UNITED STATES PATENT AND TRADEMARK OFFICE

Office Action Summary	Application No.	Applicant(s)	
	10/805,104	PAKHOMOV ET AL.	
Examiner	Art Unit		
Hoi C. Lau	2636

DETAILED ACTION

Figure 1

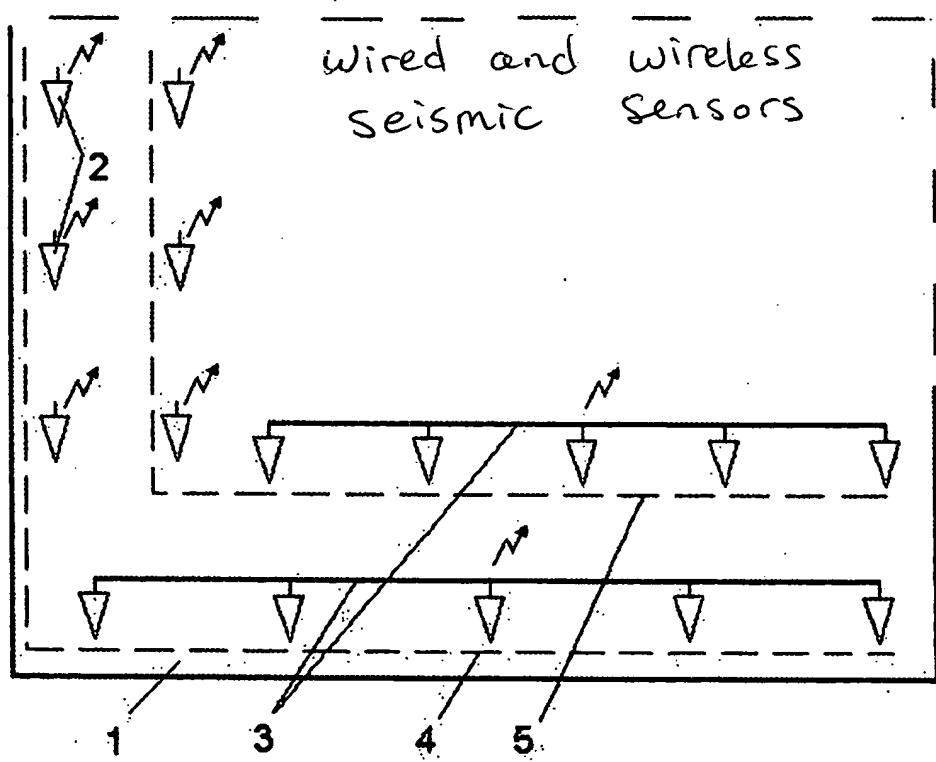
1. This application is in condition for allowance except for the following formal matters:
The drawings are objected to because the components should be labeled in drawing: Figure 1 should label "Wired and Wireless Seismic Sensors" and Figure 2 should label the components as Alarm Unit (8), CPU (6), Speaker (9), Light (10), Camera (11) and Video Recorder (12) and Figure 3 should label the components as Geophone (15), Transmitter (16), Battery (17) and Case (18). Corrected drawing sheets in compliance with 37 CFR 1.121(d) are required in reply to the Office action to avoid abandonment of the application. Any amended replacement drawing sheet should include all of the figures appearing on the immediate prior version of the sheet, even if only one figure is being amended. The figure or figure number of an amended drawing should not be labeled as "amended." If a drawing figure is to be canceled, the appropriate figure must be removed from the replacement sheet, and where necessary, the remaining figures must be renumbered and appropriate changes made to the brief description of the several views of the drawings for consistency. Additional replacement sheets may be necessary to show the renumbering of the remaining figures. Each drawing sheet submitted after the filing date of an application must be labeled in the top margin as either "Replacement Sheet" or "New Sheet" pursuant to 37 CFR 1.121(d). If the changes are not accepted by the examiner, the applicant will be notified and informed of any required corrective action in the next Office action. The objection to the drawings will not be held in abeyance.
